UNITED STATES PATENT AND TRADEMARK OFFICE

APPLICATION NO.	FILING DATE	FIRST NAMED INVENTOR	ATTORNEY DOCKET NO.	CONFIRMATION NO.
10/616,123	07/08/2003	Bradley D. Schweigert	KMC-585	2211
7590	12/01/2005		EXAMINER	
Darrell F. Marquette 2201 W. Desert Cove Phoenix, AZ 85029			HUNTER, ALVIN A	
			ART UNIT	PAPER NUMBER
			3711

Office Action Summary	Application No.	Applicant(s)	
	10/616,123	SCHWEIGERT ET AL.	
	Examiner	Art Unit	
	Alvin A. Hunter	3711

DETAILED ACTION

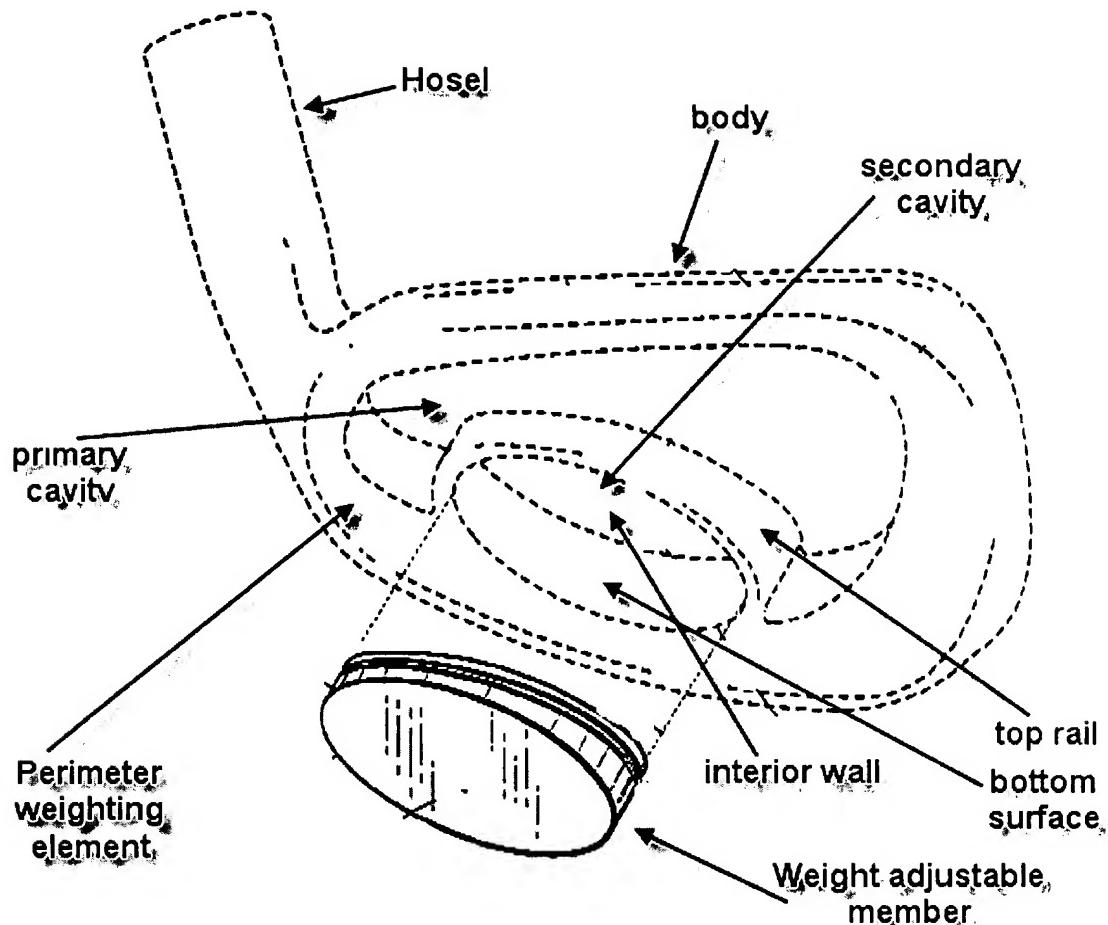
Claims 1, 4, and 5 are rejected under 35 U.S.C. 102(b) as being anticipated by Beebe et al. (USPN 6186903).

Regarding claim 1, Beebe et al. discloses a iron-type club head comprising a body having affront face arranged for impact with a golf ball, a back face, a heel portion, and a toe portion; a hosel connected to the heel portion of the body wherein the hosel has a longitudinal axis; a perimeter weighting element protruding rearwardly from the front face defining a primary cavity in the back face wherein the primary cavity has a bottom surface and the primary cavity includes a top rail extending between the heel and toe portions along an upper portion of the body and wherein the perimeter weighting element includes a sole extending between the heel and toe portions along a

lower portion of the body; an interior wall extending from a first end connected to the perimeter weighting element adjacent the body heel portion through the primary cavity between the top rail and the sole to the second end connected to the perimeter weighting element adjacent the body tow portion defining an elongated secondary cavity within the primary cavity and wherein the interior wall being integrally formed on the bottom surface of the primary cavity and extending from the bottom surface of the primary cavity in a direction that is substantially perpendicular to the longitudinal axis of the hosel thereby forming an included acute angle between the interior wall and the bottom surface of the cavity and the interior wall having a height dimension that varies between the first and second ends thereof with the height dimension of the interior wall being greater at the second end than at the first end (See Figures 1-9 and Columns 2 and 3).

Regarding claim 4, See illustration above regarding claim 1.
